EPA Superfund Record of Decision:

**Buckingham County Landfill
Superfund Site, VA,
9/30/1994**

**BUCKINGHAM COUNTY LANDFILL SUPERFUND SITE
BUCKINGHAM COUNTY, VIRGINIA**

FIGURE 3

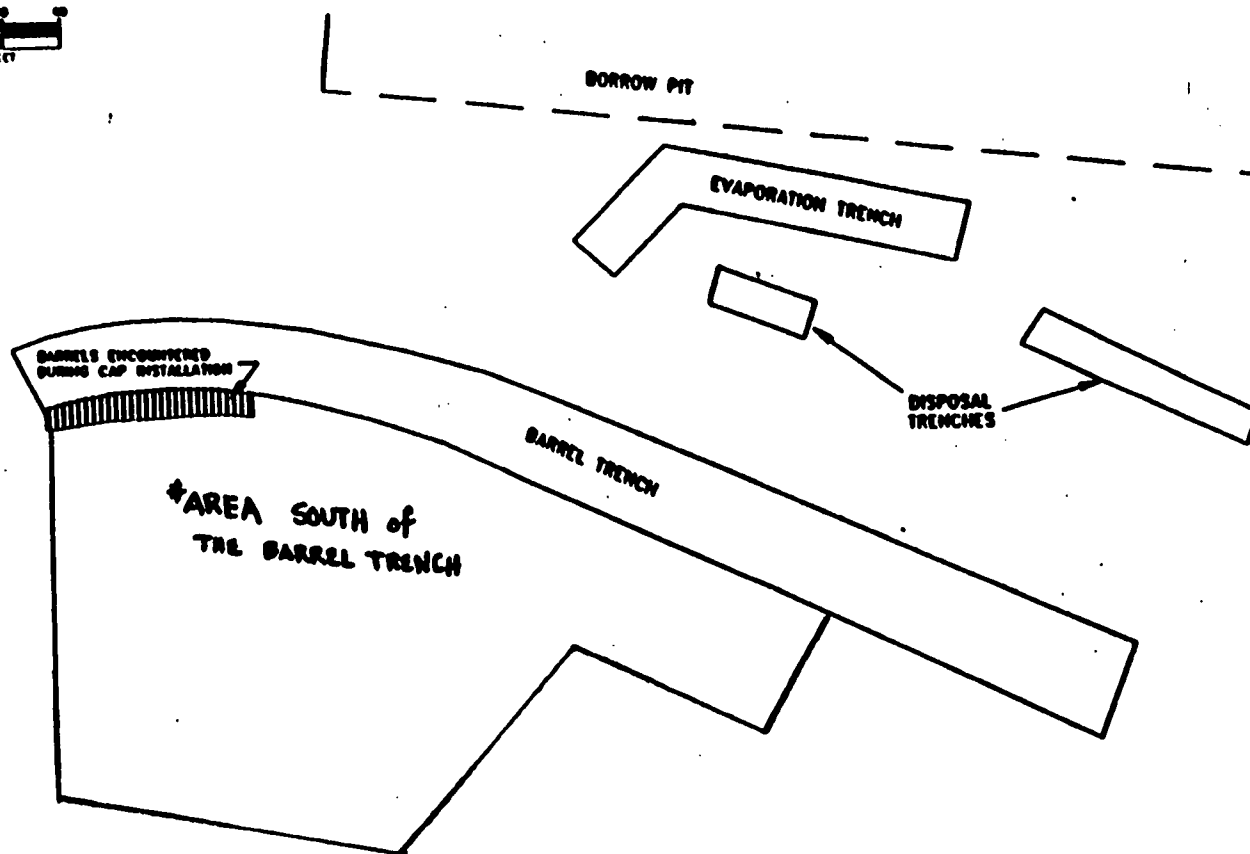
7. The area of the barrel trench has been questioned. It has been stated by the PRPs that the entire barrel trench was not represented in the proposed remedy.

EPA Response: During operations at the Site, the barrel trench was located at the southern portion of the Site and, as described on page 1-8 of the RI, was approximately 400 feet long, 20 feet wide, and 14 feet deep. This area was specifically used for disposal of supposedly empty, crushed drums. This trench was never completely filled; The west end remained open until the Site was closed in 1983. During installation of the cap in 1983, portions of empty crushed drums were found mixed in with the solid waste landfill south of the barrel trench. Fourteen test pits were dug in this area to determine if drums were disposed of throughout this area. Five test pits uncovered portions of empty drums and two pits uncovered cloth laden with solvents. There were no reports of finding drums containing hazardous wastes. EPA does not consider the area where the test pits were dug to be
